Landmarks Commission Staff Report

Re: **Certificate of Appropriateness Petition CA2022-007**

Purpose:
To approve a Certificate of Appropriateness
for the alteration of windows, siding, rear
deck, and front and rear doors.

Property Location:
2924 N. 10th Street
Kansas City, Kansas 66101

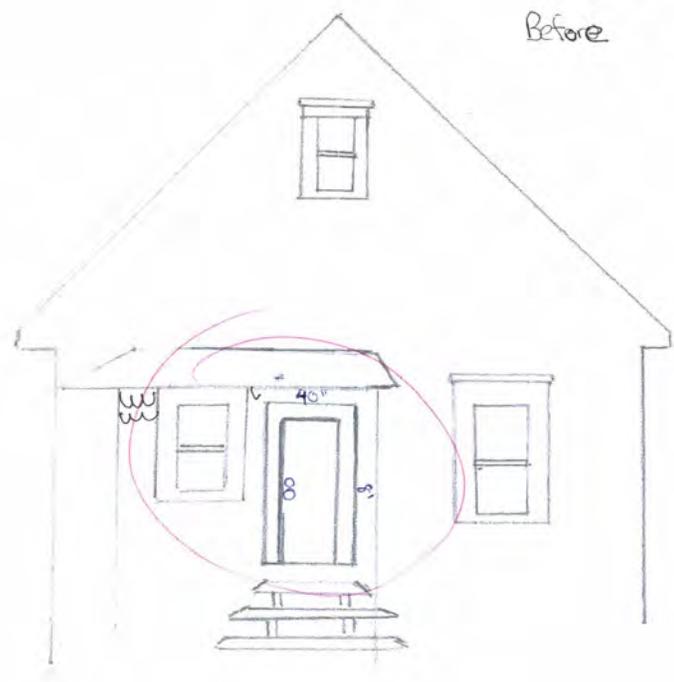
3. One (1) window in each of the North and South facades will be returned or replaced with 1/1 wooden sash windows;
4. The resized window (50%) in the north façade will be kept as is;

- SOUTH FACING SIDE OF HOUSE / 2924 N. 10TH ST., KANSAS CITY, KS 66104 / OWNER: DIANA SANDRA DAVILA.
- SCOPE OF WORK QUESTIONNAIRE / SECTION III: WINDOWS / QUESTIONS #1, 2, & 4.
- NOTES: (1) No information sheet is available. Please refer to SECTION #7, titled ADDITIONAL INFORMATION. (2) "1" Window was covered. Previous owner matched the siding with Stucco. (3) 3/6 = 1' drawing for reference.

-2924 N. 10TH ST.
KANSAS CITY, KS 66104
(FRONT OF HOUSE / EAST FACING SIDE)
-OWNER: DIANA SANDRA DAVILA
-SCOPE OF WORK QUESTIONNAIRE,
SECTION IV: DOORS, QUESTION #3:

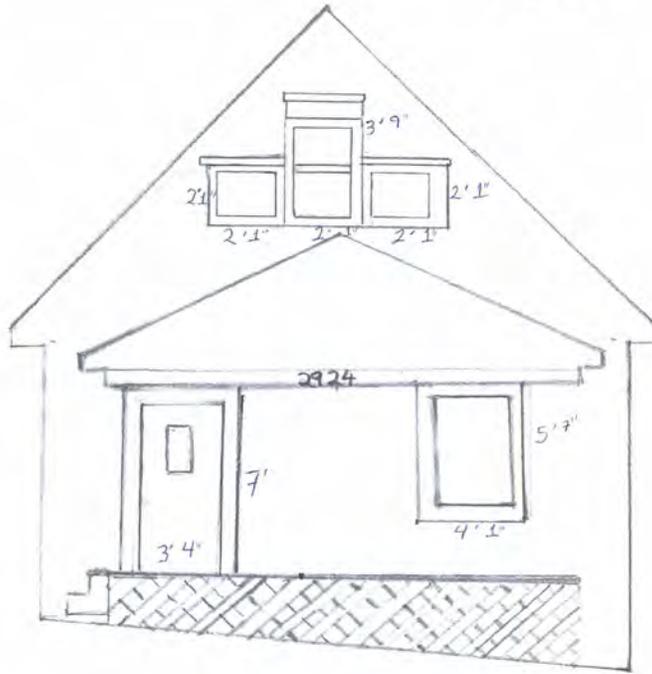
- 1. Door needs to be added to exterior. No door was available when purchased.
- 2. Picture and Spec sheet to be emailed

New single siding
 pieces to be replaced
 Same piece type will
 be used. Area (to be in
 red) shows area of repair
 Pictures to be sent.
 Exterior door to be
 added. Door missing when
 house was purchased as is
 Area of porch area, not
 livable.
 Exterior door is metal &
 36 W x 8 H

Remove or place to expose foundation rocks

- NOTES:
1. No information sheet is available.
Please refer to SECTION #7, titled
"ADDITIONAL INFORMATION".
2. FRONT VIEW OF HOUSE, FIRST FLOOR,
FRONT PORCH NOT INCLUDED.
3. One front door was moved. Same door
was used.
4. Door Description: Exterior Door H7'XW36".
One Glass Panel included.
5. $\frac{1}{4}$ " = 1' Drawing for reference.

5. The stucco surrounding the rusticated limestone foundation of the property will be removed;
6. The limestone foundation will be repointed and repaired in accordance with the Secretary of the Interior Standards for the Treatment of Historic Properties;

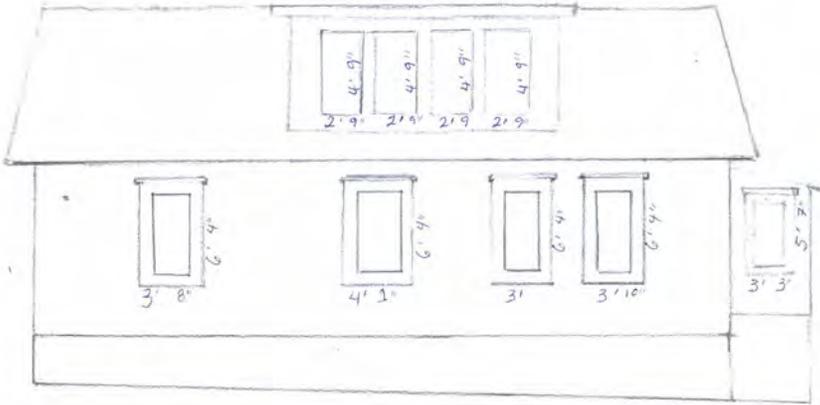
Remove of plaster expose
foundation bricks

-NORTH FACING SIDE OF HOUSE / 2924 N. 10TH ST., KANSAS CITY, KS 66104 / OWNER: DIANA SANDRA DAVILA.
-SCOPE OF WORK QUESTIONNAIRE / SECTION III: WINDOWS / QUESTIONS #1, 2, & 4. CONTINUED
-NOTES: (1) No information sheet is available. Please refer to SECTION #7, titled ADDITIONAL INFORMATION. (2) "1" Window was covered, "1" Window's size was reduced by half in size. Previous owner matched the siding with Stucco. (3) 3/16 = 1'
